**ADDENDUM 2**  
To Contract Documents for  
**EYECARE MEDICAL GROUP**  
53 SEWALL STREET  
PORTLAND, ME 04102

**E.M.G. - Phase 2 Addition & Renovation**

EYECARE MEDICAL GROUP  
PHASE 2 ADDITION AND RENOVATION  
ADDENDUM NO. 2  
July 15, 2013

SHEET  
SKS-05

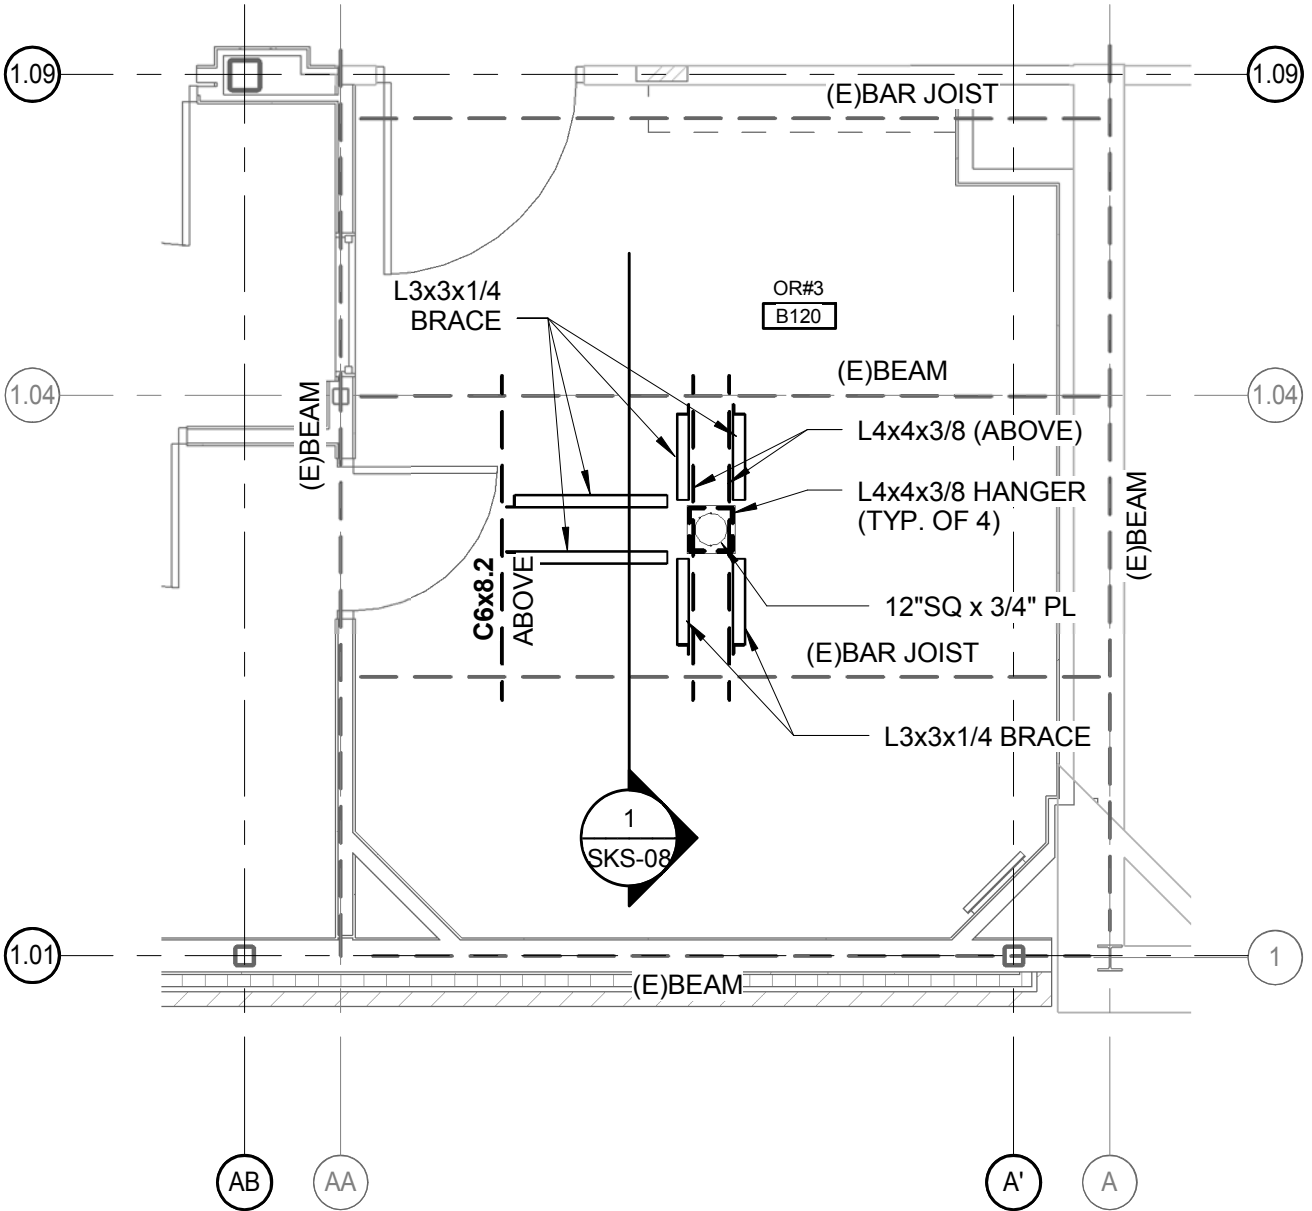
1. ADD ORN04 light support framing plan SKS-05.
2. ADD OR N03 light support framing plan SKS-06.
3. ADD typical light support detail SKS-07.
4. ADD typical light support detail SKS-08.
5. ADD typical light support details SKS-09.
6. CHANGE partial roof framing plan as indicated on SKS-10.
7. ADD detail at parapet along line-8 as indicated on SKS-II.

SHEET  
SKA-1

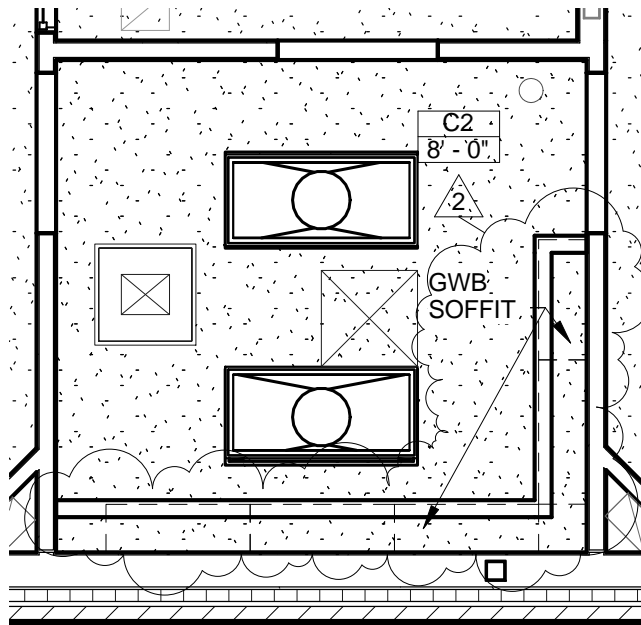
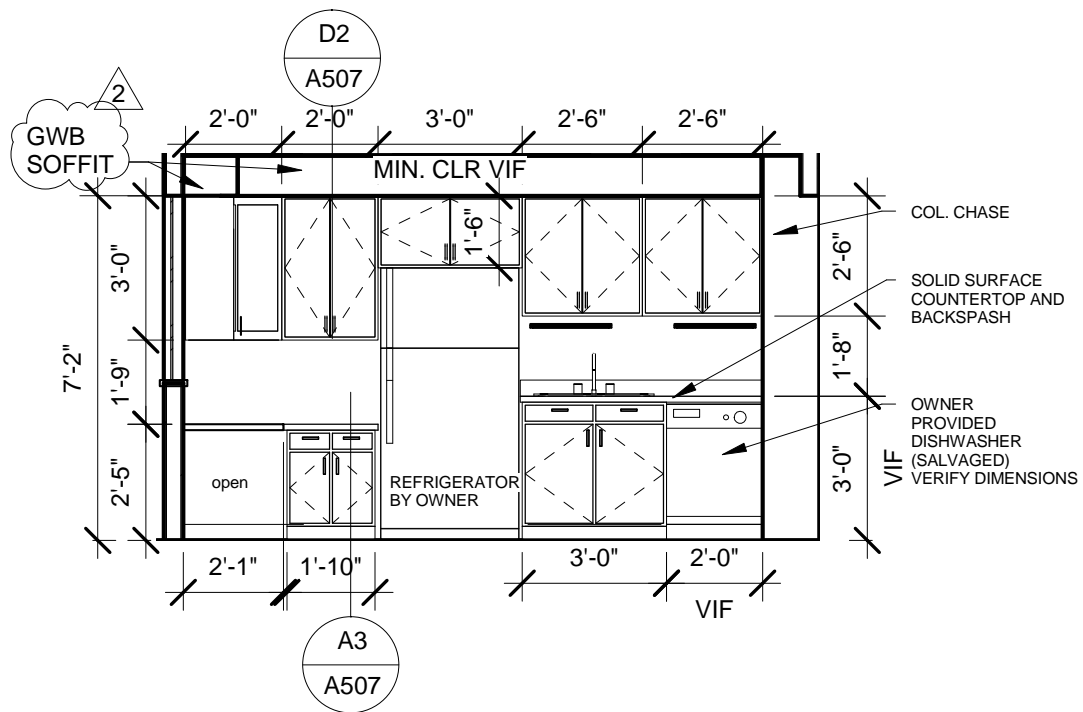
- 1.** ADD soffits in Autoclave B119 as indicated on SKA-1.
- 2.** ADD soffits in Nurse B108 as indicated on SKA-2.
- 3.** REPLACE elevation A5/A201 with SKA-3, clarifying wall lighting layout.

**SHEET**  
SKP-2

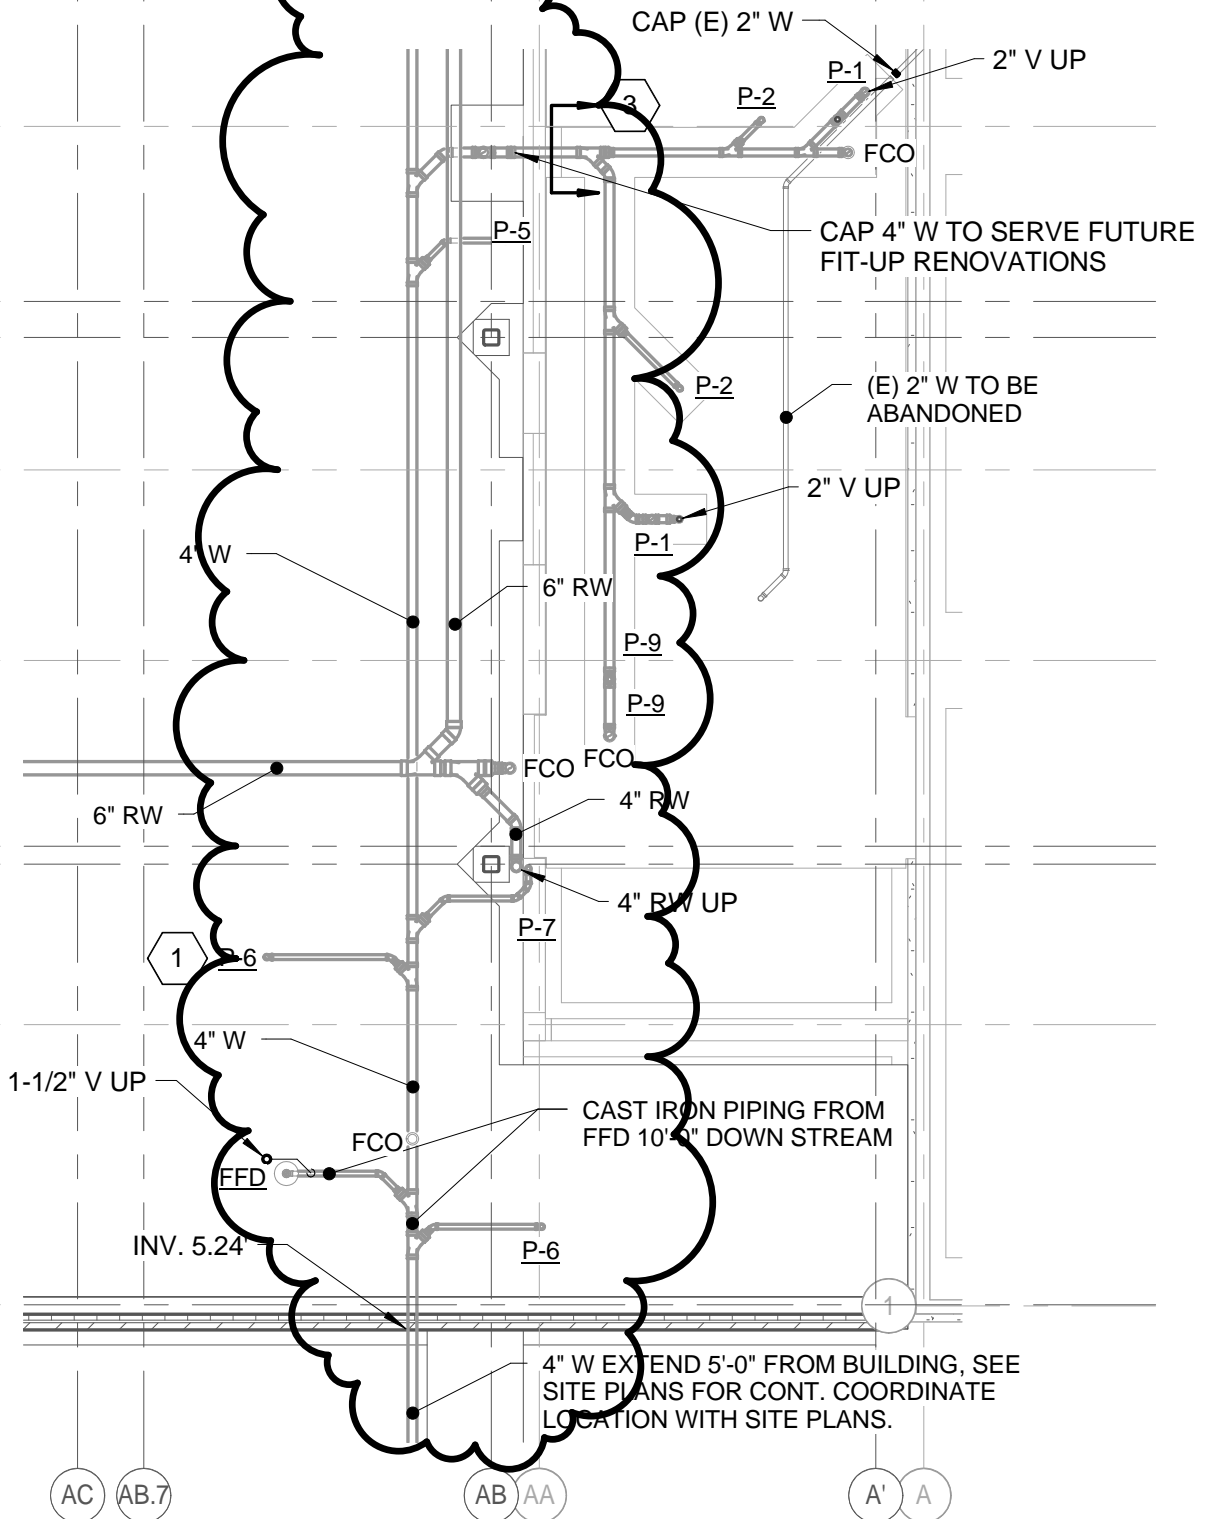
- 1.** CHANGE under slab domestic water and sprinkler entrance as indicated on SKP-1.
- 2.** DELETE under slab domestic water and sprinkler entrance indicated on SKP-2.
